A46 Newark Bypass

7.33 Applicant's Responses to Examining Authority's First Written Questions

**Applicant's Responses to
Examining Authority's First Written Questions**

Version	Date	Status of Version
01	November 2024	Deadline 2

Figure 5.2: Extract from Sheet 4 of 7 of the General Arrangement Plans [AS-007]. The area of the interface with the GTC Pipeline Ltd asset has been highlighted in yellow.

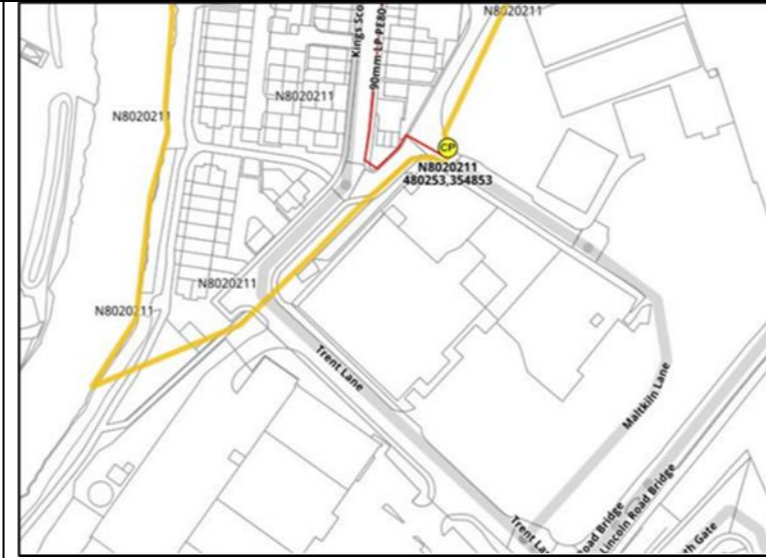
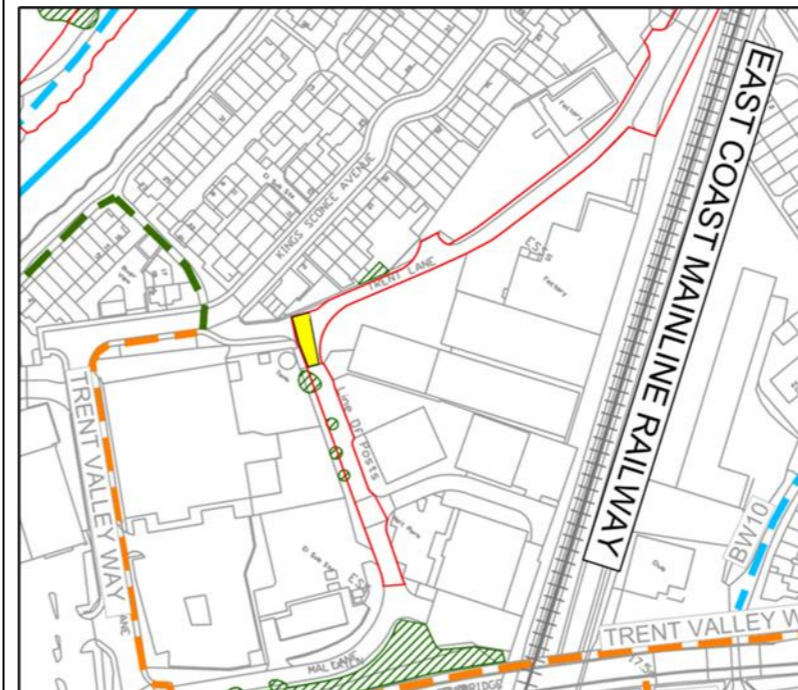
Q5.0.5	The Applicant, GTC Pipelines Ltd	<p>GTC Infrastructure GTC identify the location of their infrastructure and the plot numbers within which their infrastructure is located that may be affected or parts of the Proposed Development that may affect their infrastructure. The Applicant to explain how it has sought to address this potential impact on the infrastructure and what is the latest position.</p>	<p>The Applicant confirms GTC Pipelines Limited raised a Relevant Representation [RR-027] on 24 June in which they identified two potential interfaces between their assets and the Order Limits. A response was provided to [RR-027] in the Applicant's Response to Relevant Representations [REP1-009].</p> <p>The Applicant has contacted GTC Pipelines Limited detailing the interface at the two identified areas. GTC Pipelines limited have responded thanking the Applicant for the information and provided confirmation that the GTC Pipeline Assets are not affected by the Scheme.</p> <p>Location 1: Maltkin Lane, Newark</p> <p><u>GTC Asset Description</u> 90mm LP PE80 pipe located beneath the concrete access track at the northern end of Maltkin Lane at the junction with Trent Lane.</p>

The Applicant is seeking to use this land temporarily as an access road to access the construction areas at the Nether Lock Viaduct and obtain permanent rights to allow for maintenance access to the new assets that are to be constructed. Malkin Lane and Trent Lane currently provide access to the industrial estate and Nether Lock and are used by National Highways, and other asset owners. The Applicant is not undertaking any permanent works at this location and will not be undertaking any excavation on the existing access road.
